Office Action Summary

10/528,207

HAGEN, HARALD

(marked Kim Figure 4)

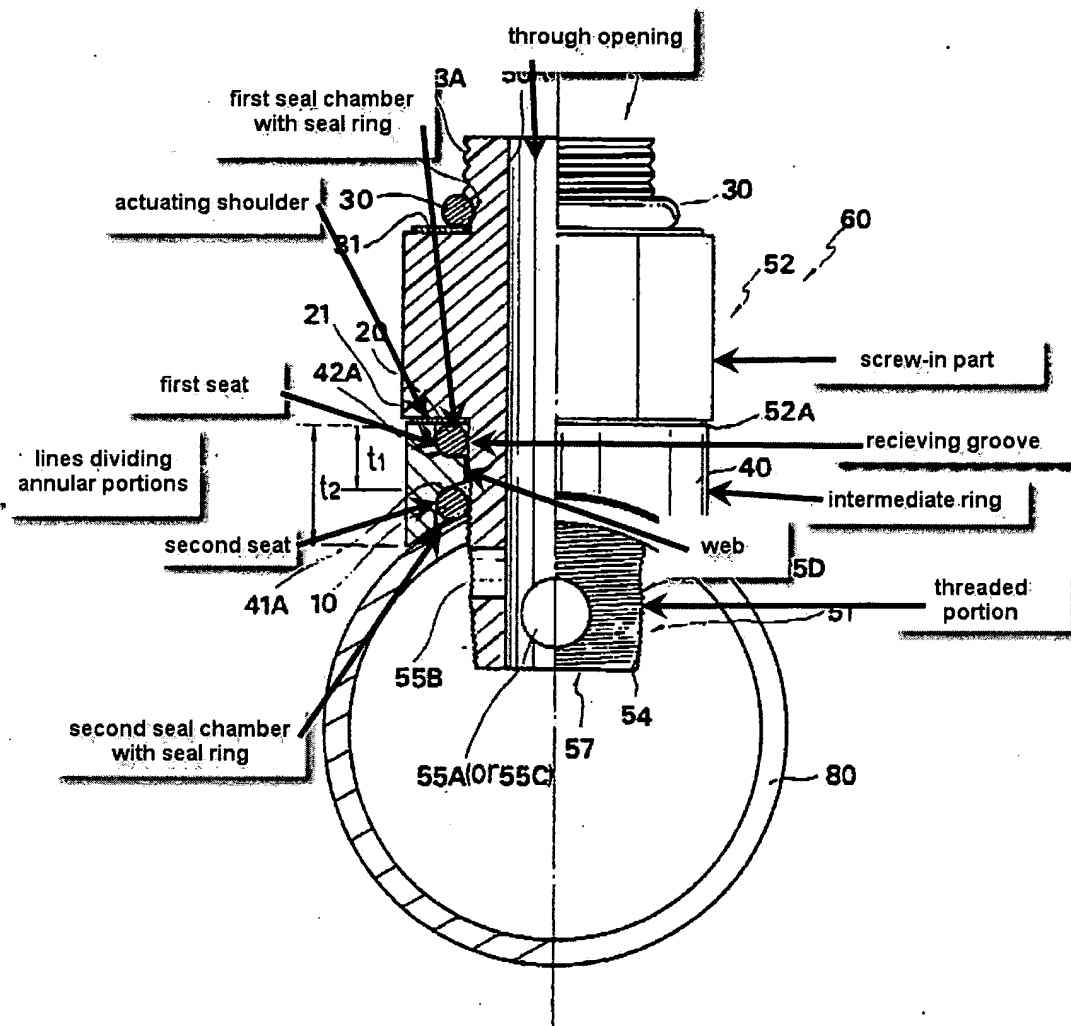
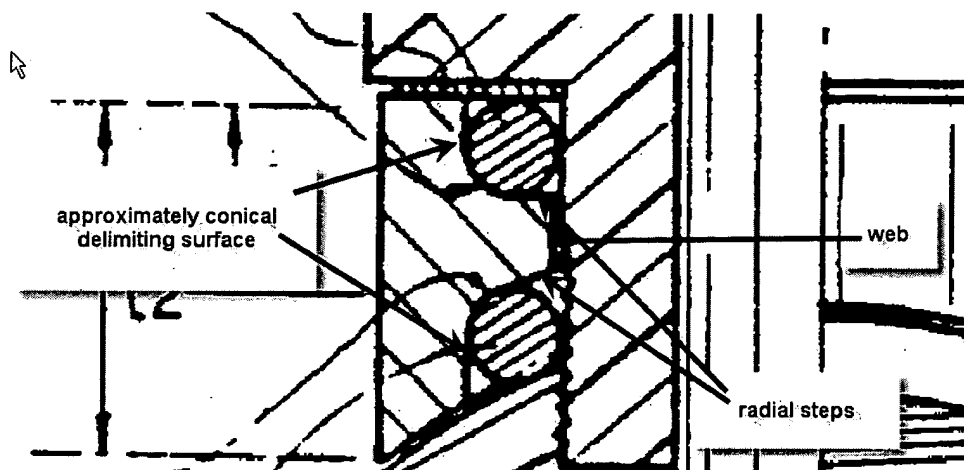
21. In regard to claim 1, Kim, in Figure 4 below, discloses an intermediate ring (part 40) for a screw-in part (part 52) of a fluid plug-in system, the screw-in part having a through-opening (as observed in marked Figure 4 below), an externally threaded portion (part 54) for screwing into a threaded bore of a base part, an actuating shoulder (as observed in marked Figure 4 below), and a receiving groove (as observed in marked Figure 4 below and as part 56, a smooth surface above

the threaded portion in Figure 2A), formed in the transition between the actuating shoulder and the externally threaded portion with a sealing ring comprising the intermediate ring adapted to be fitted onto the externally threaded portion (as observed in Figure 4 below) and having first and second axially opposite annular portions (as observed in marked Figure 4 below), the first annular portion, having on a side facing the actuating shoulder, a first seat (part 42A), which, together with the receiving groove and the actuating shoulder, forms a first seal chamber (as observed in Figure 4 below) for the first sealing ring, and the second annular portion having a second seat (part 41A) for a second sealing ring such that, when the screw-in part is screwed into the threaded bore having a surrounding surface adjacent on the mouth side, a second seal chamber (as observed in Figure 4 below) for the second sealing ring is formed between the second seat, the surrounding surface and the externally threaded portion.

22. In regard to claim 2, Kim discloses the intermediate ring further comprising two sealing ring seats and the associated sealing rings are formed such that, in a mounted state, compression of the first and second sealing rings is achieved and in this connection the second sealing ring is compressed mainly axially essentially without radial deformation acting against the externally threaded portion (in column 5, lines 47-57, the dimensions of the seal chambers and their respective seals are disclosed, directly related to seal compression; in column 7, lines 38-64, the sealing action of intermediate ring and seals is disclosed and no disclosure is made of essential radial deformation of the second seal ring towards the threads; and as observed in Figure 4 below, the second seal is not deformed against the threads to a degree greater than any of the of the surrounding surfaces of the chamber).

23. In regard to claim 3, Kim discloses that the intermediate ring first and second annular portions are separated by an internal radial annular web (as observed in marked Figure 4 below), which divides the first and second seats from one another.

24. In regard to claim 4, Kim discloses the intermediate ring sealing ring seats formed by a radial step surface and an approximately conically widening delimiting surface adjacent to it on the outside (as observed in marked cut-out of Figure 4 below).

25. In regard to claim 5, as best understood, Kim discloses that the thickness of the intermediate ring is dimensioned according to the threaded bore and the screw-in part together with additional parts mounted thereon, such that a plug holding element can be screwed in completely to compress the first sealing ring and the plug part can be plugged completely into the through-opening of the screw-in part into a plugged-in position (in column 5, lines 47-57, the dimensions of the seal chambers and their respective seals are disclosed, directly related to seal compression; in column 7, lines 38-64, the sealing action of intermediate ring and seals is disclosed and no seal activity could occur if the intermediate ring were too long or too short; and the a plug part can be inserted into the through-opening, the amount of insertion dependent upon plug part dimensions).

26. In regard to claim 6, the Figure 4 cross-hatching indicates the material is metal. Note, it is the patentability of the product, and not recited process steps, that is to be determined and thus how the intermediate ring was formed is of little consequence to the patentability determination of the final product. Kim possesses an intermediate ring that meets the structure of the claim.

(marked Neuschotz Figure 4)

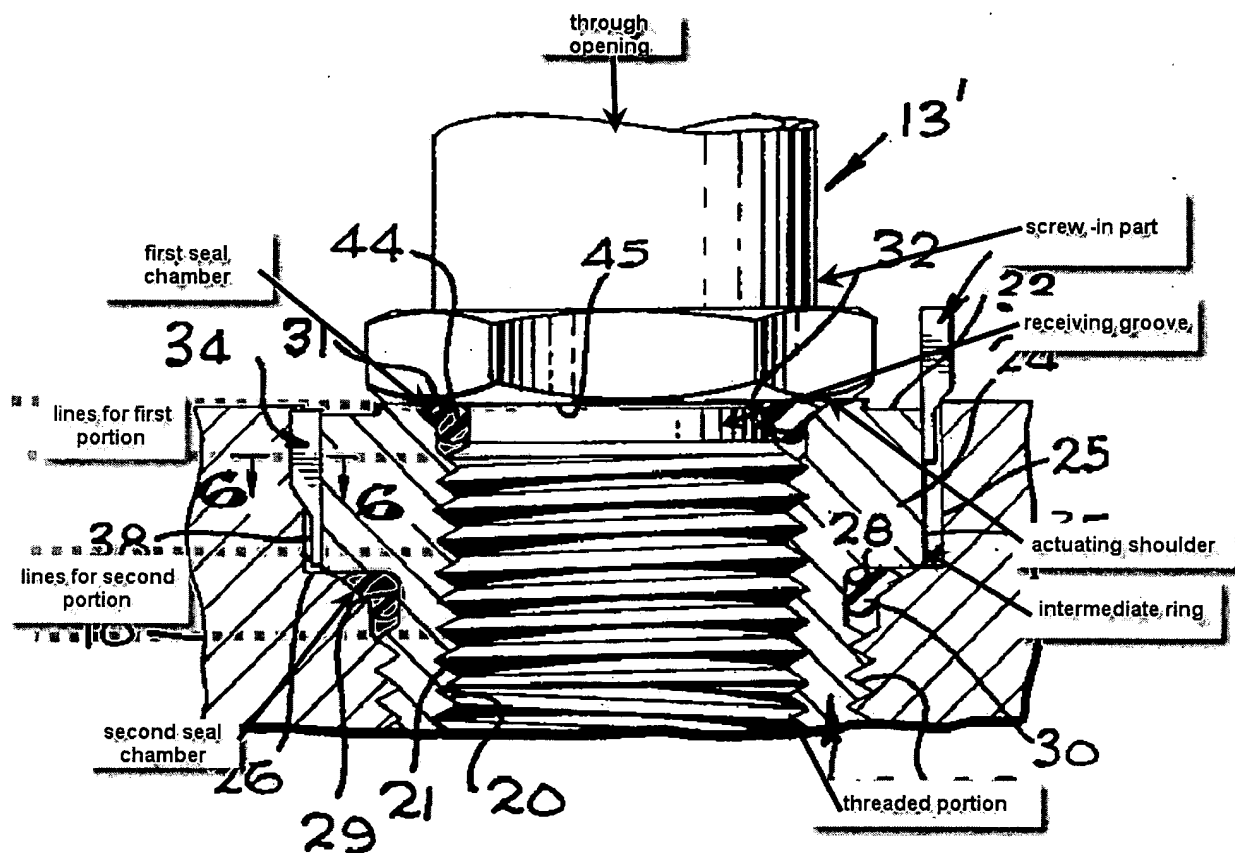
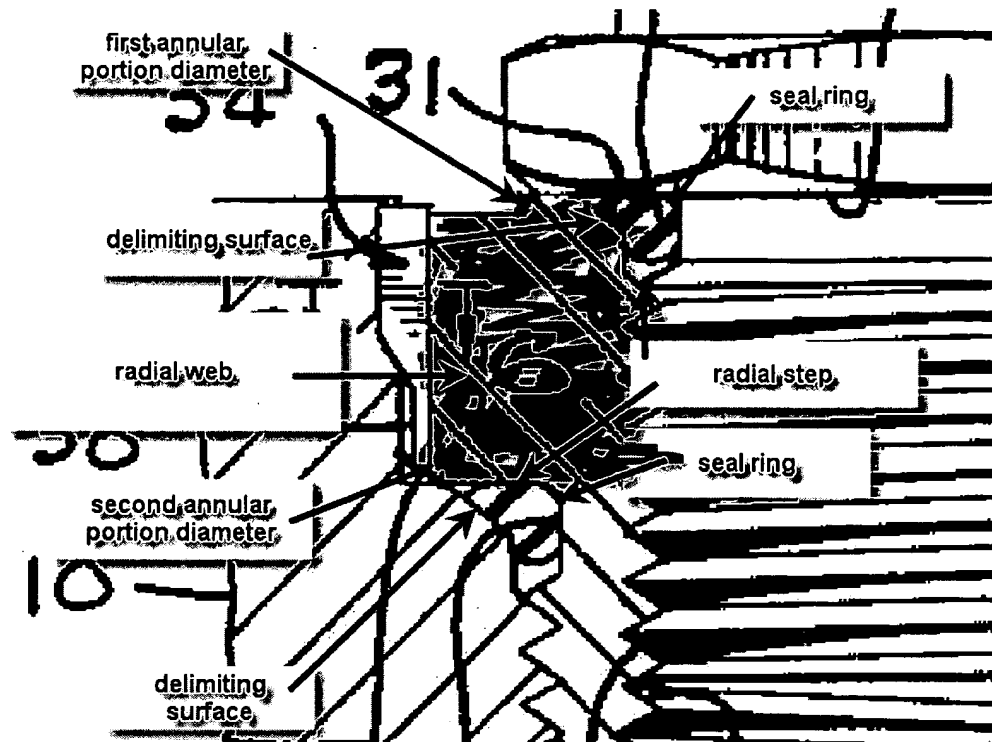
28. In regard to claim 1, Neuschotz, in Figure 4 below, discloses an intermediate ring (as observed in marked Figure 4 below) for a screw-in part (as observed in marked Figure 4 below) of a fluid plug-in system, the screw-in part having a through-opening (as observed in marked Figure 4 below), an externally threaded portion (as observed in marked Figure 4 below) for screwing into a threaded bore of a base part, an actuating shoulder (as observed in marked Figure 4 below), and a receiving groove (as observed in marked Figure 4 below), formed in the transition between the actuating shoulder and the externally threaded portion with a sealing ring comprising the intermediate ring adapted to be fitted onto the externally threaded portion (as observed in Figure 4 below, the intermediate ring is on the threaded portion of the screw-in part) and having first and second axially opposite annular portions (lines added to marked Figure 4 below to emphasize the portions), the first annular portion, having on a side facing the actuating shoulder, a first seat (part 31), which, together with the receiving groove and the actuating

shoulder, forms a first seal chamber (as observed in Figure 4 below) for the first sealing ring, and the second annular portion having a second seat (part 28) for a second sealing ring such that, when the screw-in part is screwed into the threaded bore having a surrounding surface adjacent on the mouth side, a second seal chamber (as observed in Figure 4 below) for the second sealing ring is formed between the second seat, the surrounding surface and the externally threaded portion.

29. In regard to claim 2, Neuschotz discloses intermediate ring further comprising two sealing ring seats and the associated sealing rings are formed such that, in a mounted state, compression of the first and second sealing rings (as observed in marked cut-out of Figure 4) is achieved and in this connection the second sealing ring is compressed mainly axially essentially without radial deformation acting against the externally threaded portion (as can be observed in marked cut-out of Figure 4, the second seal ring does not contact the threads).

30. In regard to claim 3, Neuschotz discloses that the first and the second annular portions are separated by an internal radial web (as observed in marked cut-out of Figure 4 below), which divides the first and second seats from one another.

31. In regard to claim 4, Neuschotz discloses the intermediate ring sealing ring seats formed by a radial step surface and an approximately conically widening delimiting surface adjacent to it on the outside (as observed in marked cut-out of Figure 4 below).

32. In regard to claim 6, Neuschotz discloses that the first annular portion is designed to be smaller in diameter than the second annular portion (as observed in marked cut-out of Figure 4).

(marked Hagen et al Figure 8)

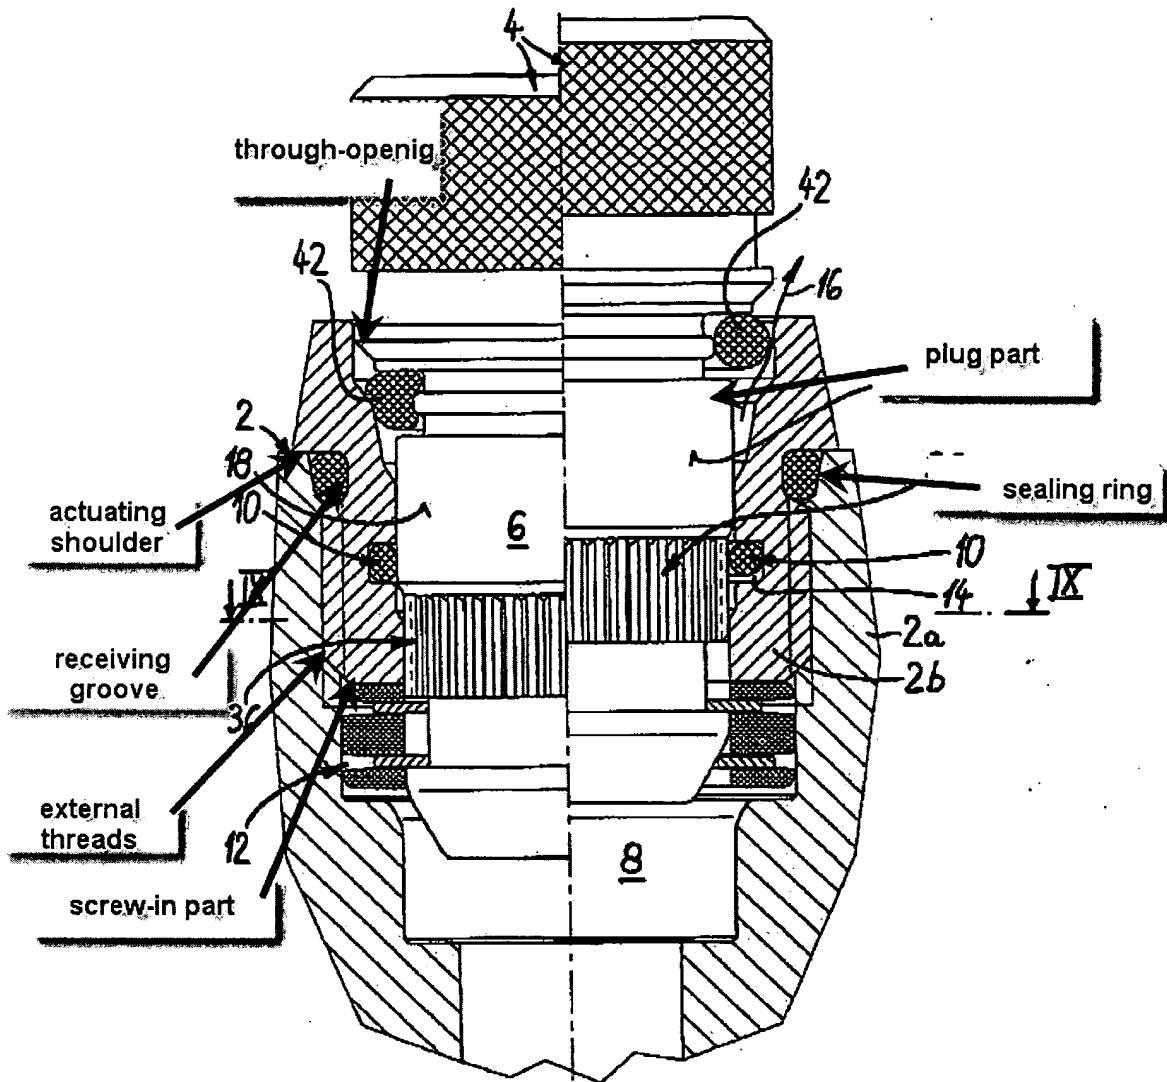
36. In regard to claim 1, Hagen et al, in Figure 8 below, disclose the claimed invention except for the sealing ring comprising an intermediate ring having a first and a second axially opposite annular portions, the first annular portion having on a side facing the actuating shoulder, a first seat, which, together with the receiving groove and the actuating shoulder, forms a first seal chamber for the first sealing ring, and the second annular portion having a second seat for a second sealing ring such that, when the screw-in part is screwed into the threaded bore having a surrounding surface adjacent on the mouth side, a second seal chamber for the second sealing ring is formed between the second seat, the surrounding surface and the externally threaded portion. Creamer, in Figure 5 below, teaches a sealing ring with an intermediate ring to allow a screw-in part to be radially orientated in a base part (column 1, lines 53-58). It would have been obvious to one of ordinary skill in the art at the time the invention was made to provide the screw-in part of Hagen et al with the sealing ring as taught by Creamer to allow radial orientation of the screw-in part in the base part.

(marked Creamer Figure 5)

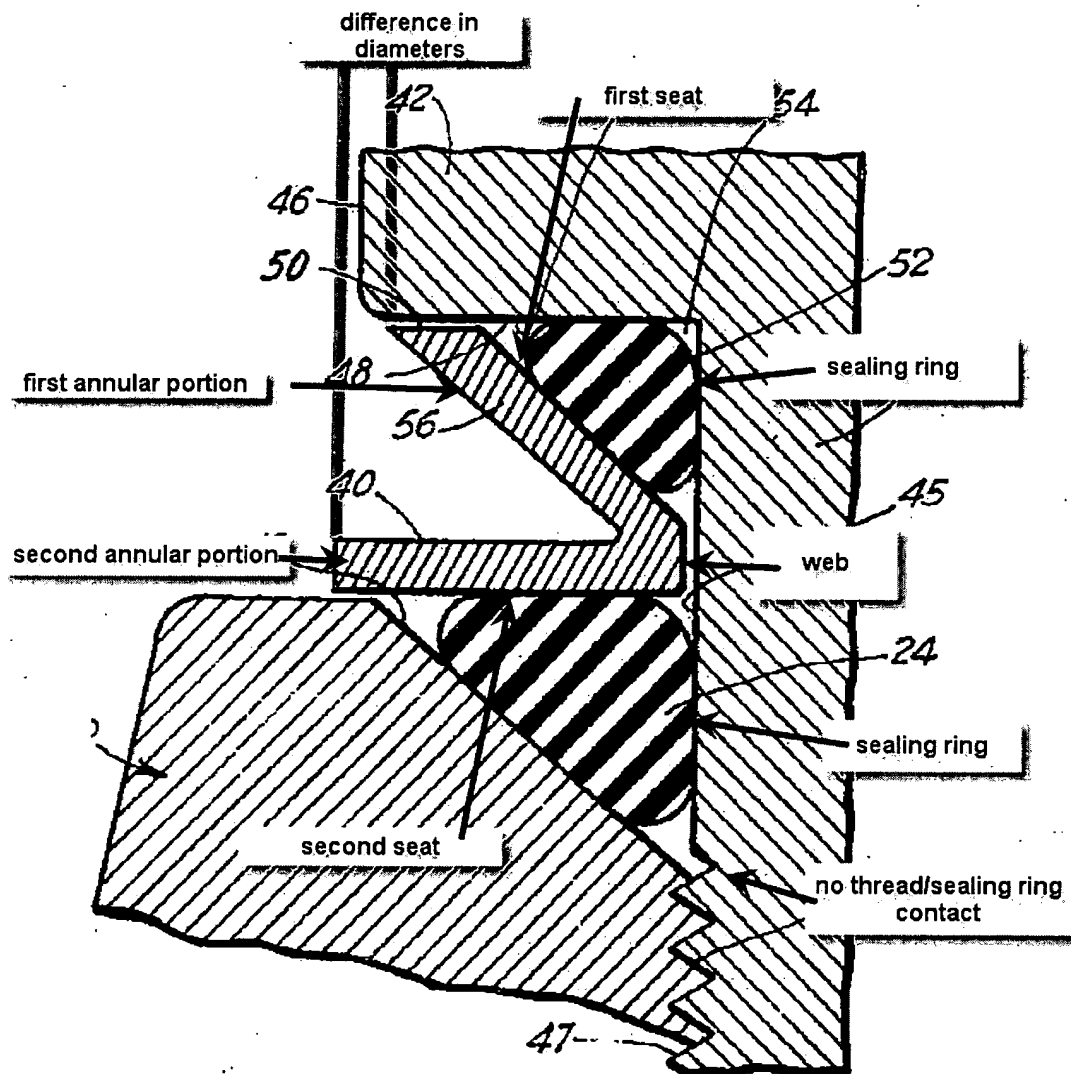
40. In regard to claim 6, Creamer further teaches that his intermediate ring has a first annular portion smaller in diameter than the second annular portion (as observed in marked Figure 5 below).
